SUBJECT: TECHNICAL SAFETY ANALYSIS OF PRM-50-76, A PETITION FOR
RULEMAKING TO AMEND APPENDIX K TO 10 CFR PART 50 AND
REGULATORY GUIDE 1.157

**Technical Safety Analysis of PRM-50-76
A Petition for Rulemaking to Amend
Appendix K to 10 CFR Part 50 and
Regulatory Guide 1.157**

Figure 1. Parabolic Rate Constants for Oxygen Consumption

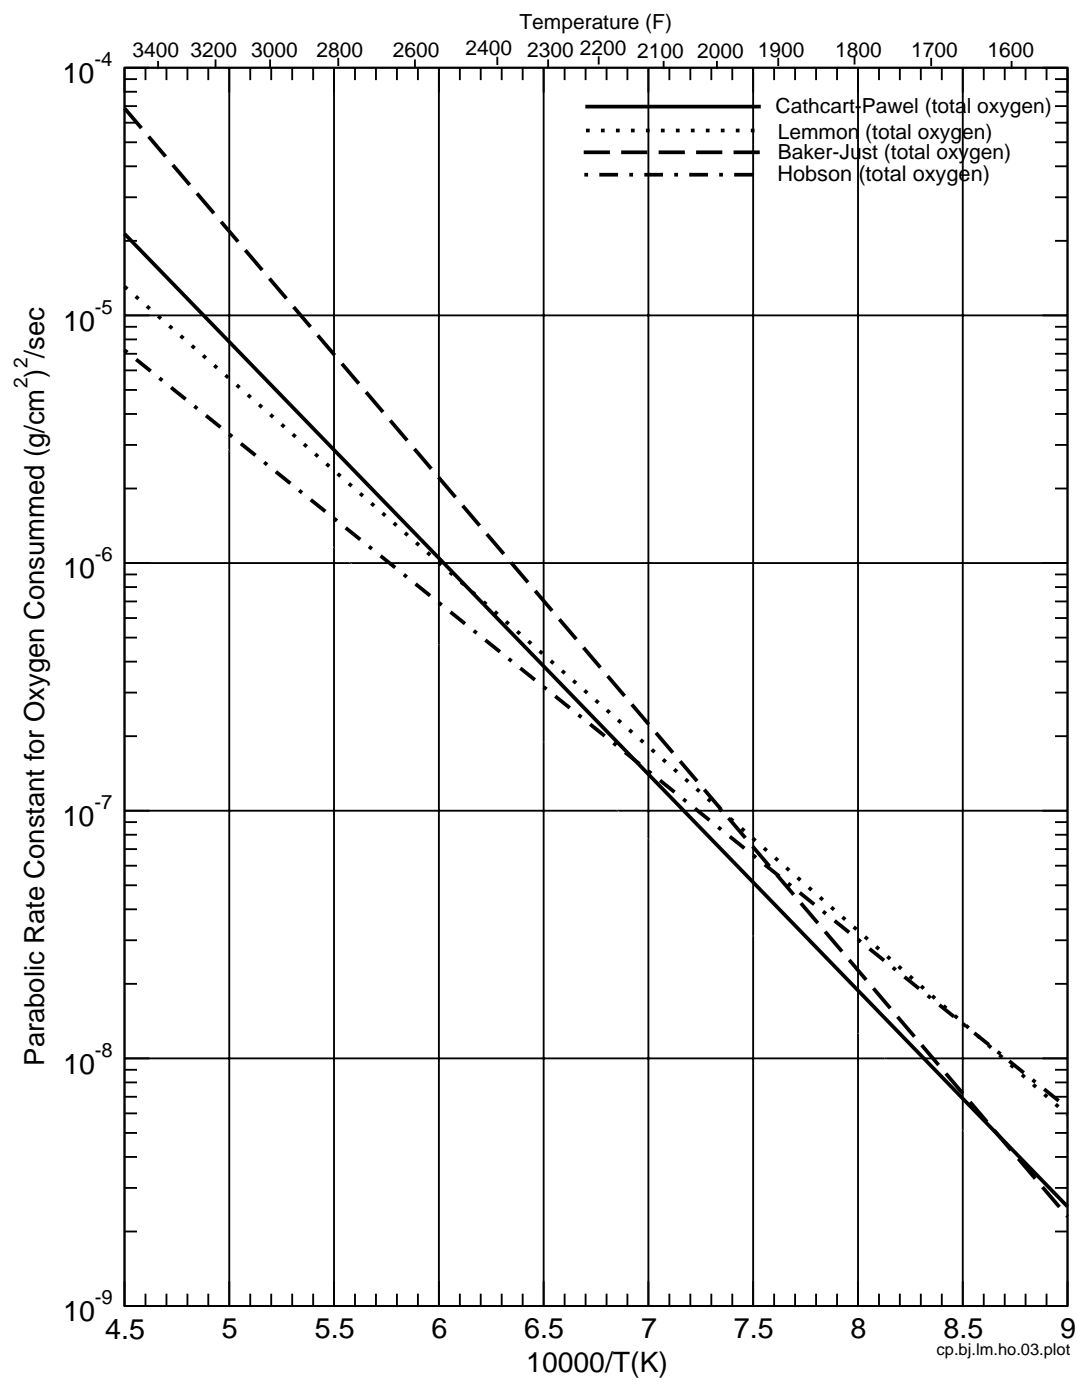
Correlations known at the time of the ECCS hearing included that of Lemmon (Reference 14) and Hobson and Rittenhouse (Reference 15). Those two correlations are shown in Figure 1 along with Baker-Just (Reference 4) and Cathcart-Pawel (Reference 5). The Commission in Reference 6 expressed uncertainty about the Hobson-Rittenhouse data based on the hearing record. For these reasons the Commission admonished the staff that new and better zirconium-water reaction data should be obtained (Reference 6). The Commission did recognize that the data used to develop the correlations shown in Figure 1 (with the exception of Cathcart-Pawel of course, which did not yet exist) indicated a degree of conservatism in the Baker-Just equation. Subsequent discussions in this report related to Section 3.3 of the petition will further address the conservatism of the Baker-Just equation.

Figure 2. Stoichiometric Steam Flow for MiniZWOK

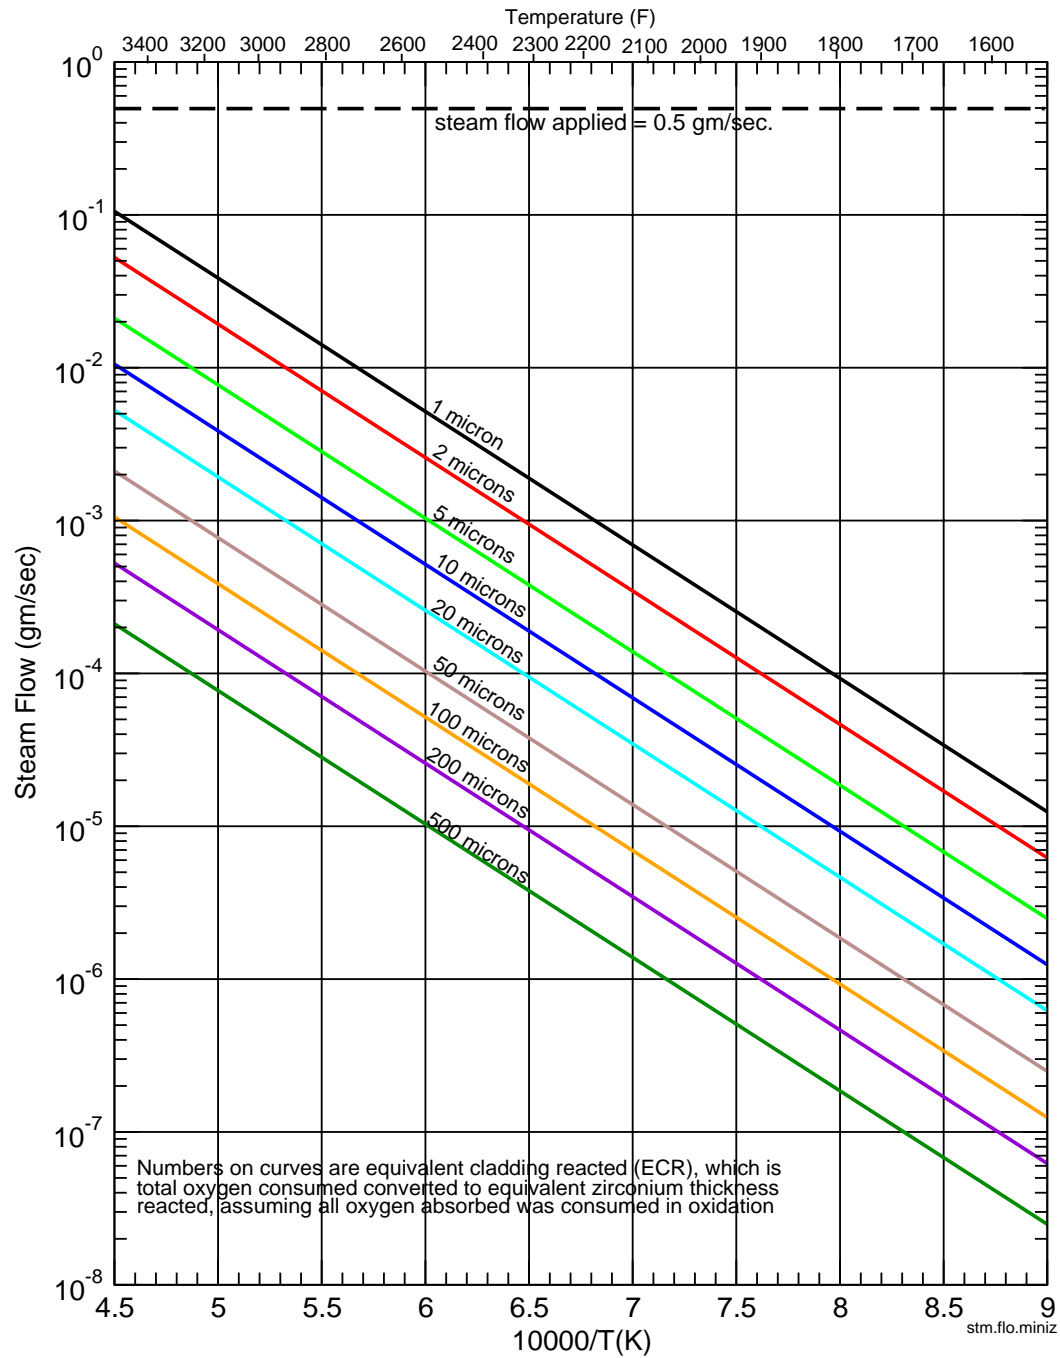
With respect to adequate steam flow, calculations were performed to assure that this was the case for the MiniZWOK experiments used to derive the Cathcart-Pawel correlation (Reference 5). The Cathcart-Pawel total oxygen consumption equation was applied to the MiniZWOK apparatus for a range of equivalent cladding reacted (ECR) for those particular tube specimen dimensions. The variable calculated was the stoichiometric steam flow required for the calculated reaction rate at the particular sample temperature and ECR. The results shown in Figure 2 indicate that for an ECR as small as 1 micron, at a sample temperature of 2400°F, the applied steam flow (0.5 gm/sec.) is 100 times greater than the stoichiometric requirements. Calculations using the Cathcart-Pawel correlation for the transient temperature oxidation experiments in Reference 5, indicate that an ECR as small as 1 micron exists for less than 3 seconds even for temperatures as low as 1700°F. Obviously the reaction would be steam starved at any applied flow rate less than the calculated value, but some steam starvation could occur if the flow is not in close proximity to the sample surface. In this apparatus the channel width around the sample is about 0.75 in. Anything that increases the ECR, which happens throughout any transient, will reduce the reaction rate and thus the steam flow requirements. Figure 2 shows that for temperatures as high as 200°F above the current 50.46 limits, the steam flow used in the MiniZWOK experiments was at least two orders of magnitude more than would be needed to avoid stoichiometric steam starvation.

Figure 3. FLECHT Measured vs. Predicted Oxide Thickness

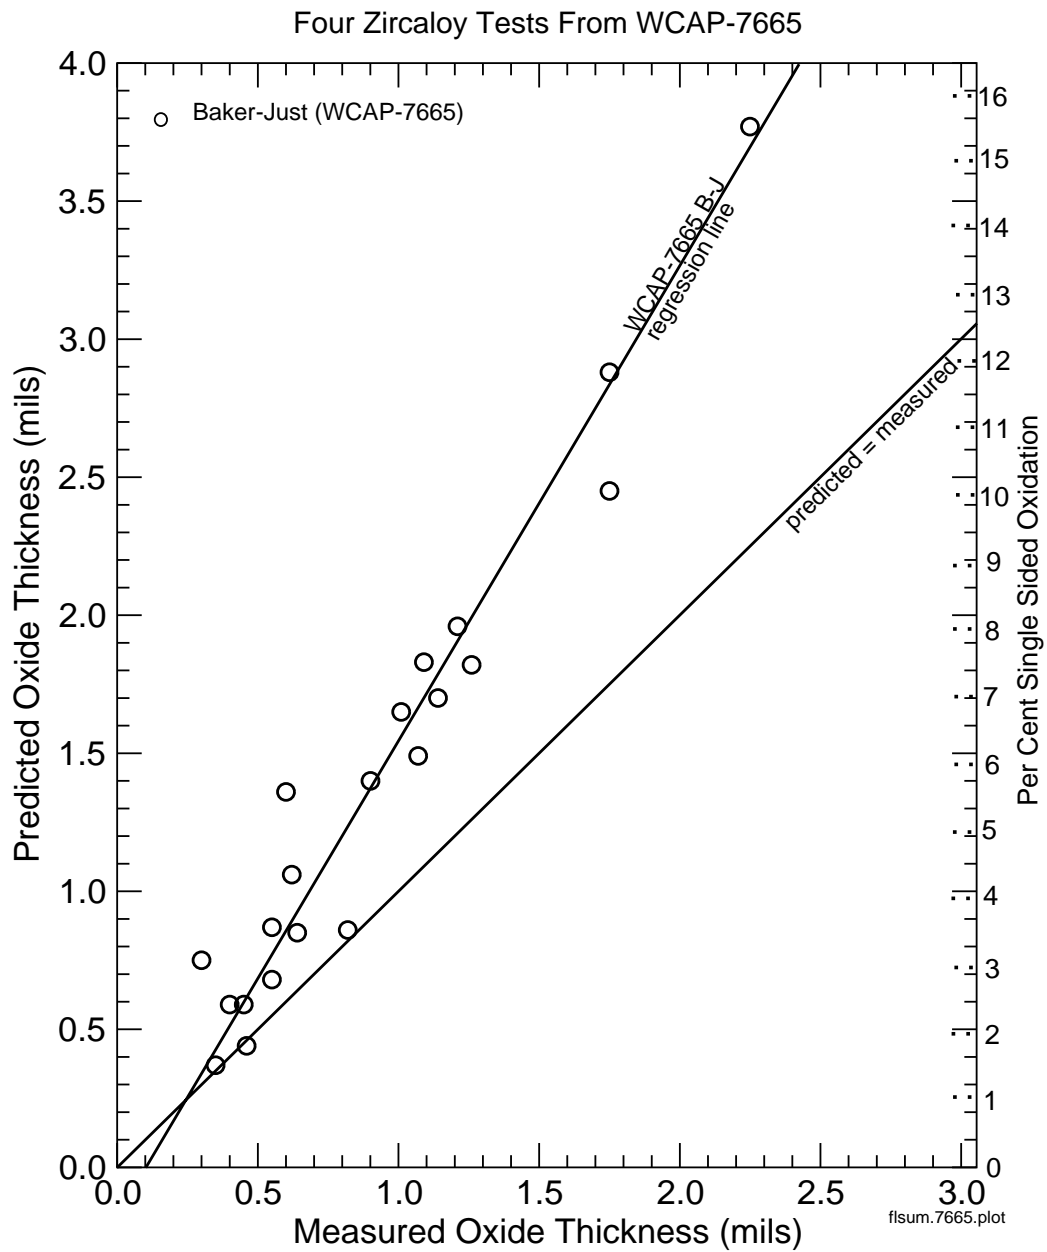
The NRC obtained tabular time/temperature data from Westinghouse for 19 of the 21 locations analyzed by Westinghouse for the four Zircaloy FLECHT tests. The Baker-Just correlation was applied to these 19 data sets as a check on the analysis in Reference 7. The Cathcart-Pawel oxide thickness correlation was also applied to the 19 available data sets. The predicted vs. measured points for these two applications are shown in Figure 4. The regression line for the 19 point Baker-Just application is shown along with the predicted = measured line. The Baker-Just regression line and data points in Figure 3 and Figure 4 are nearly identical, indicating a good check of the Baker-Just application in Reference 7. As can be seen in Figure 4, the data points for the Cathcart-Pawel application lie close to the predicted = measured line, indicating

that Cathcart-Pawel is a good fit to this data set. The 2σ variances of the points of the Baker-Just applied points about the Baker-Just regression line in Figure 4 is 0.38 mils. The 2σ variances of the Cathcart-Pawel applied points about the predicted = measured line is only 0.27 mils. Therefore, not only does the Cathcart-Pawel correlation provide a better representation of typical LOCA transient oxidation data, the variance of the applied correlation is also better.
